merCruiser STERN DRIVES & INBOARDS

service bulletin

No. 90-6

Shift Plate Inspection

Figure 1.

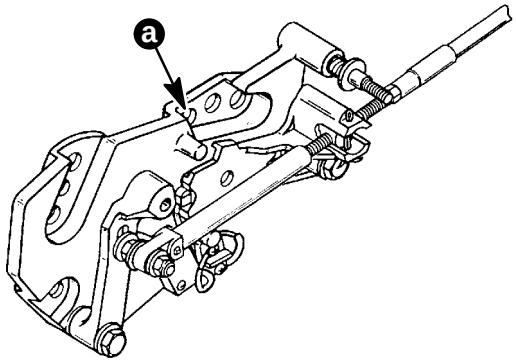
When servicing these engines, check to see if shift plate is tight against exhaust elbow in area of bolt (a) shown in Figure 1.

Figure 2.

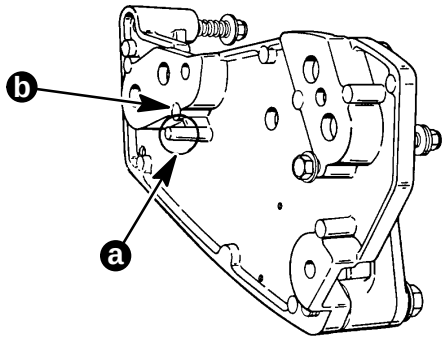
If plate is not tight against elbow, remove plate. File enough material off of locating pin (a) until it is flush with plates mounting surface (b). See Figure 2. Repaint bare metal. Install plate back on elbow. Torque bolts to 100 lb. in. (11 N·m).
